## CITY OF TONTITOWN PLANNING OFFICE

Meeting: **June 22, 2021**  
Project: **Venetto Subdivision**  
Planner: Courtney McNair,  
Garver

### PRELIMINARY SUBDIVISION PLAT APPROVAL REQUEST

415 N. Mantegani Road  
Parcel # 830-37688-000

PRELIMINARY PLAT  
VENETTO SUBDIVISION  
TO THE CITY OF TONTOWN,  
WASHINGTON COUNTY, ARKANSAS  
PART OF THE NE ¼ NW ¼, SECTION 2,  
T-17-N, R-31-W

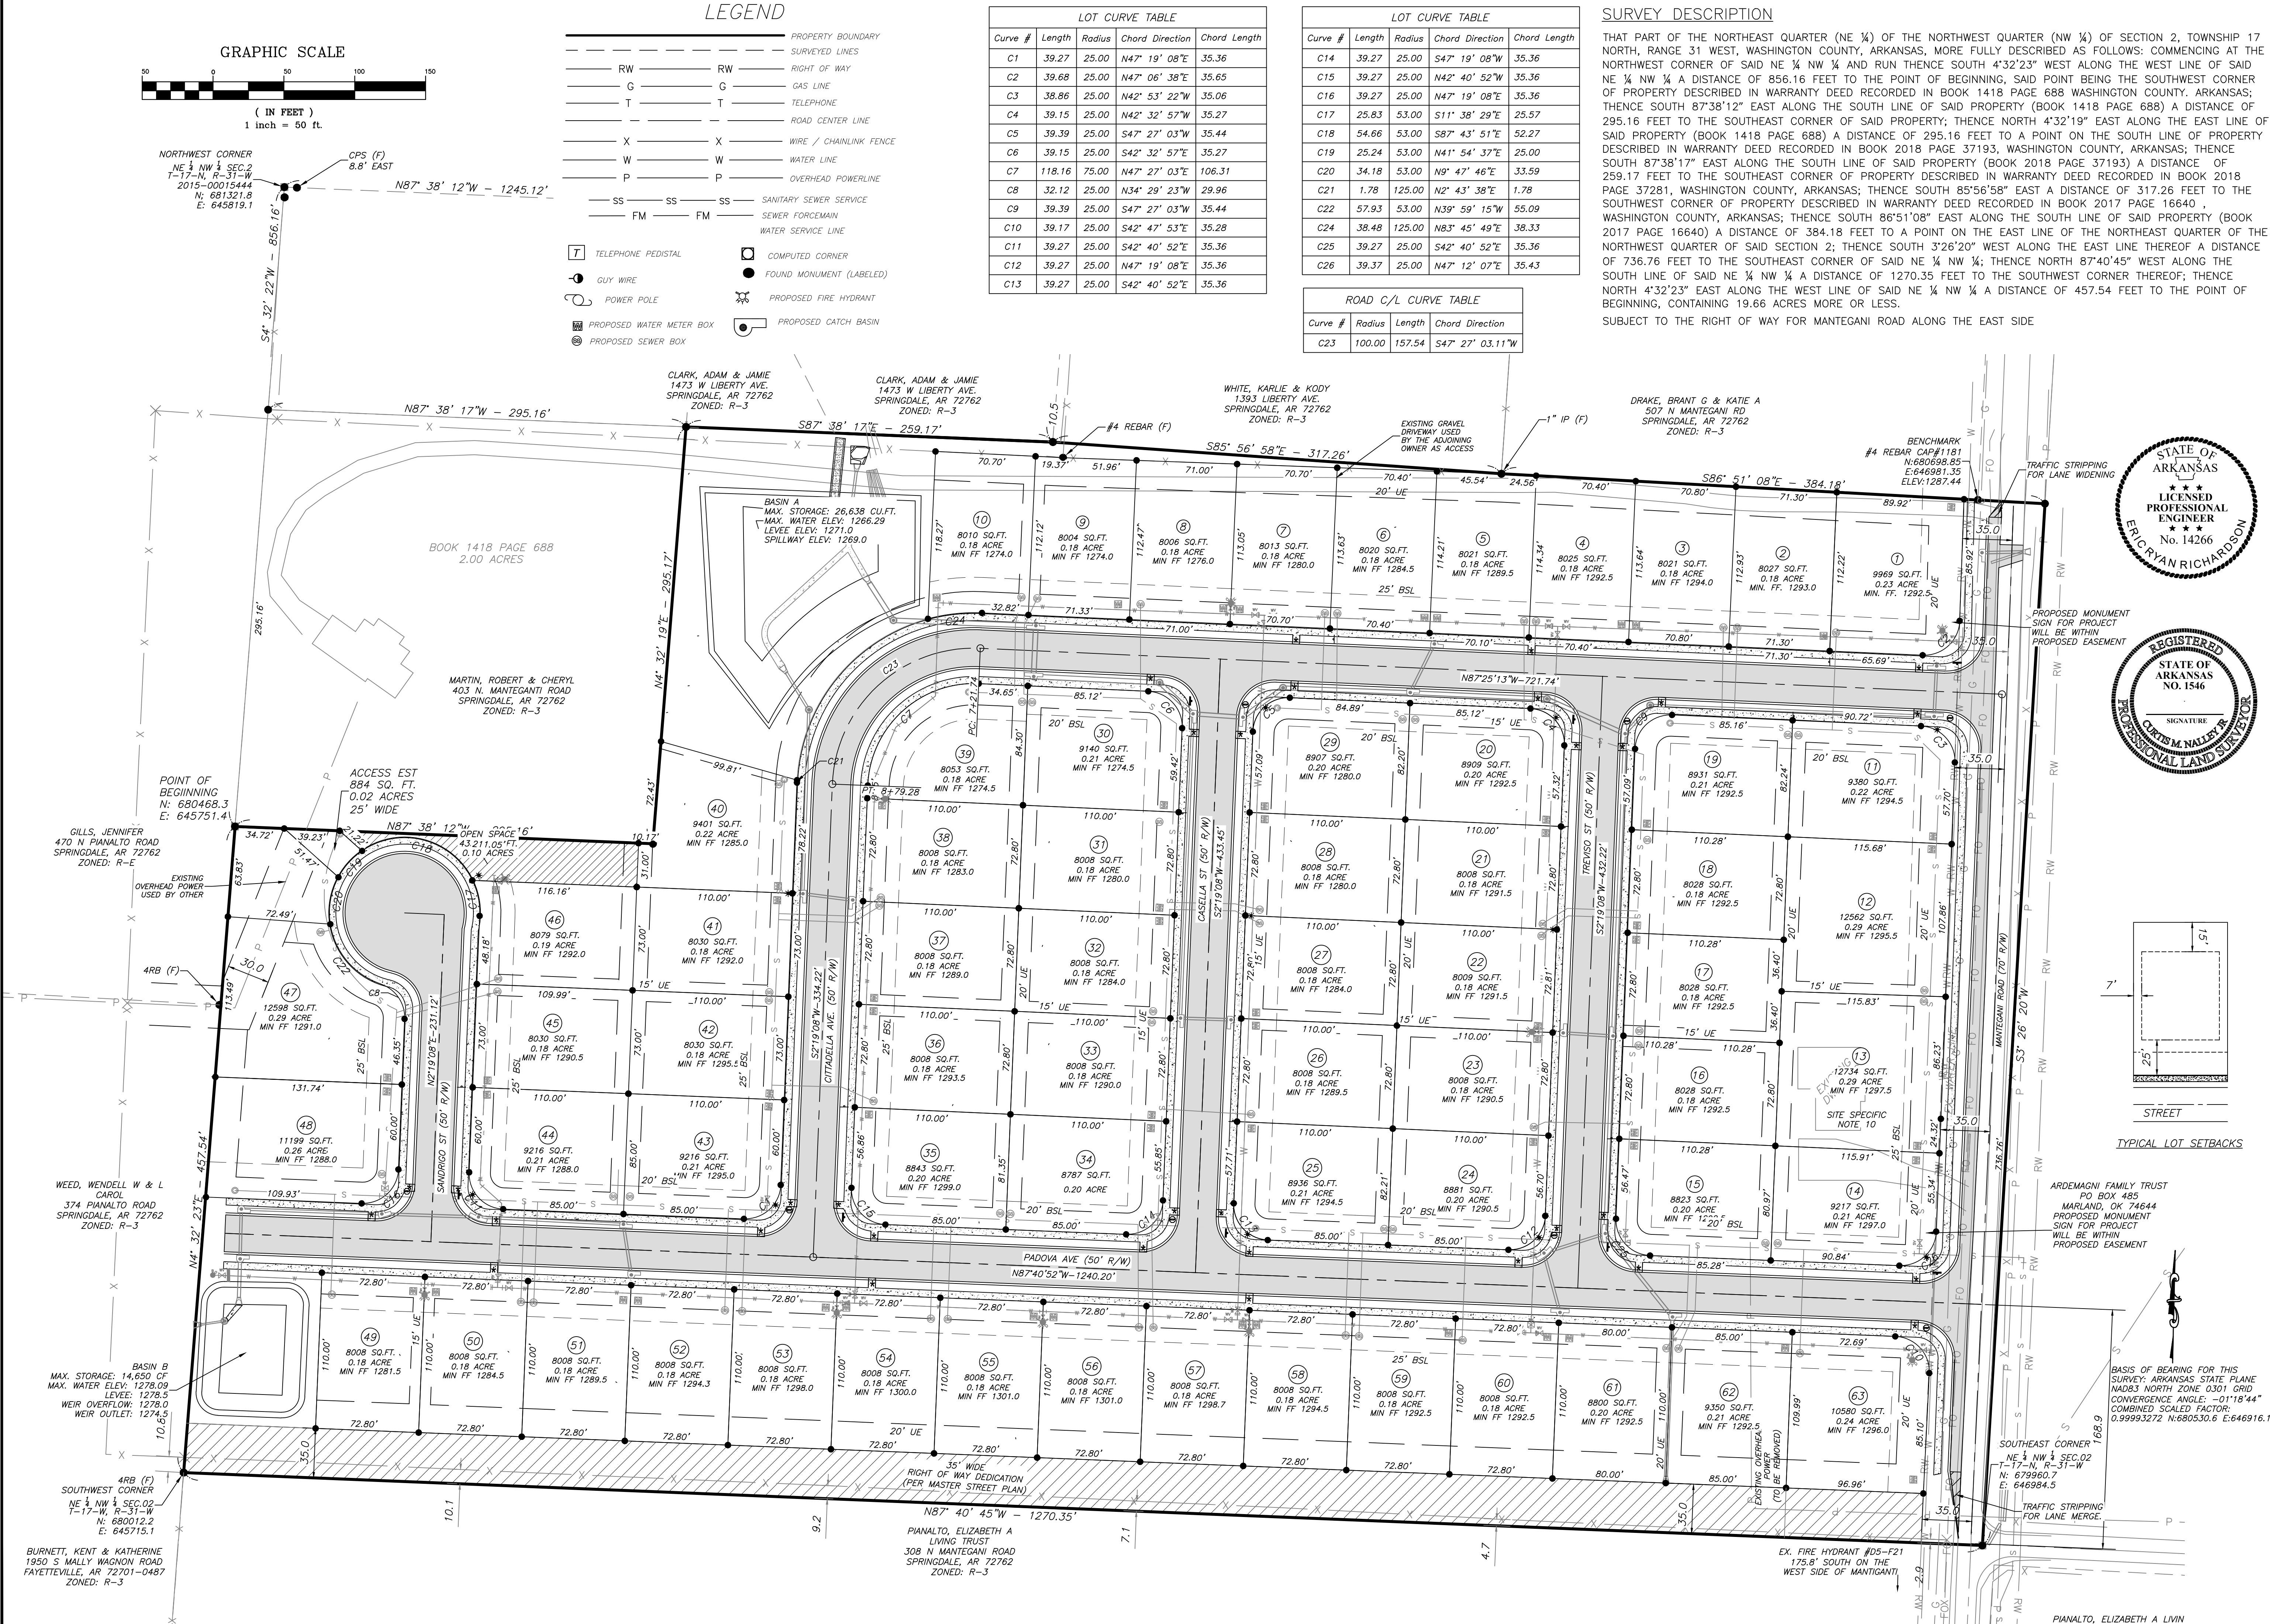
This project has road frontage on Mantegani Road along the east property line and is required to provide an extension of Sbanotto/Bariola Ave along the south property line. They are showing one future connection point to the west, but none to the north.

The applicant requested a waiver to not construct the extension along the south. If the waiver was denied as recommended by staff, the applicant will be required to submit new plans that show the required extension.

Additionally, there is an existing access drive that provides access for the neighbor in the northwest corner. It needs to be clearly indicated on the plans if this access drive is to be removed, and what configuration is decided upon to provide access for this property. There is not an existing easement.

Several lots are proposed to take direct access onto the Collector Streets. While this is not preferred, code does not specifically prohibit this. Whenever possible, individual residential subdivision lots shall access on to the interior Local Streets.
